IEC 63171-4
Edition 1.0 2022-09

Part 4: Detail specification for shielded or unshielded, free and fixed connectors
with up to 8 ways for balanced single-pair data transmission with current carrying capacity –
Mechanical mating information, pin assignment and additional requirements for Type 4

CORRIGENDUM 1

4.1.3.1 Shielded and unshielded fixed connector – MMC 1P

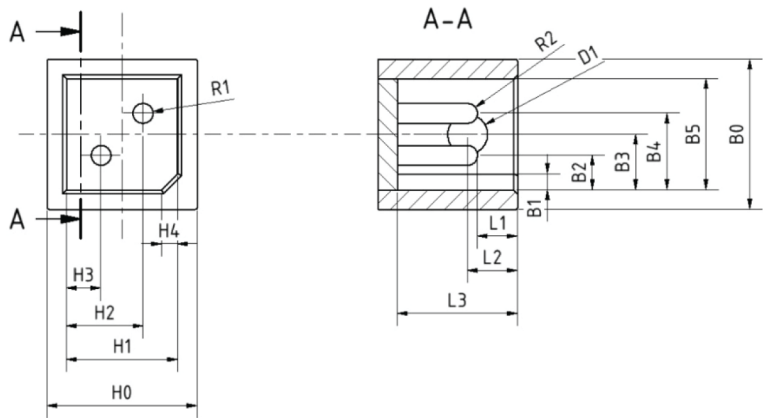
Replace existing Figure 3 with the following new Figure 3:
